REPUBLIC OF MOLDOVA
ROAD SECTOR PROGRAM

ADDENDUM No.1

to the Tender Documents

**RSP/W14/01: Construction of Road M3 Chisinau – Comrat –
Giurgiulesti – Romanian border, sector Vulcanesti bypass (km 0+000
– km 8+580)**

Figure 1 – soil reinforcement unit (module) of steel hexagonal meshes

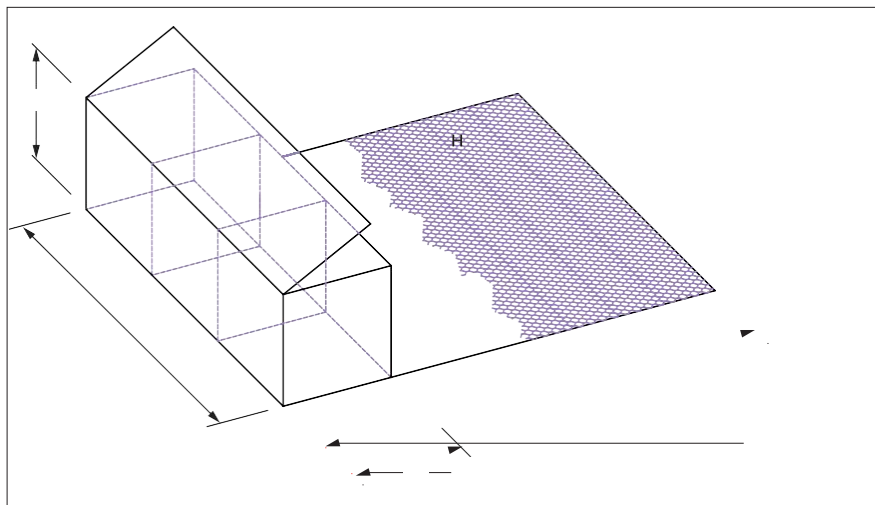
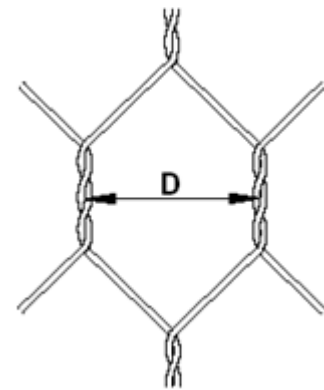
Section VI: Requirements, Technical Specifications, the technical specifications for Module Mineral Terramesh System in the Sub-Chapters 901.03 Materials and 901.05 Acceptance of Works, Volume III – Technical Specifications, is modified by adding the following text:

- Soil reinforcement units (modules) of DT steel wire mesh, of long-term durability in the form of gab-tail gabions according to Figure 1

The units (modules) will be produced of double-twisted steel wire with 8x10 cm hexagonal meshes (Figure 1).

Figure 3

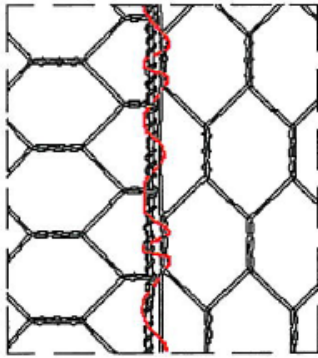
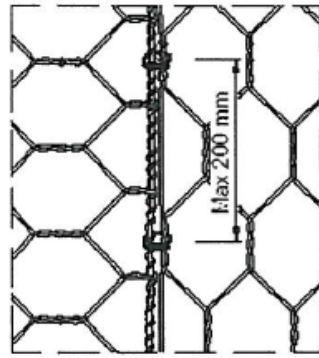
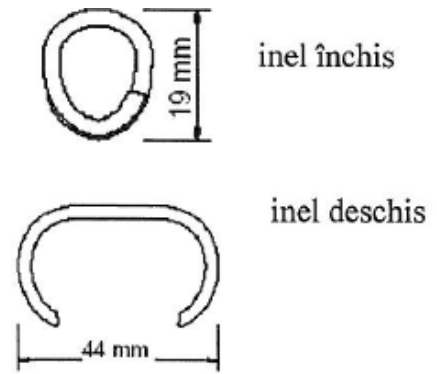
- a) the folded structure must be placed on a flat, clean ground without vegetation;
- b) after placement, the side, front and back walls and diaphragms shall be raised and tied up. The fastening wire is delivered together with the structure. For a correct joint, the wire must go through each mesh and twisted twice at every second mesh (Figure 2), by means of a manual or pneumatic twisting machine. Instead of fastening wire, Galvan-coated steel rings may be used (Figures 3, 4) having the following characteristics:
 - diameter: min. 3,0 mm;
 - tensile strength: min. 1700 N/mm²

The space between the rings must not exceed 200mm (Figure 3).
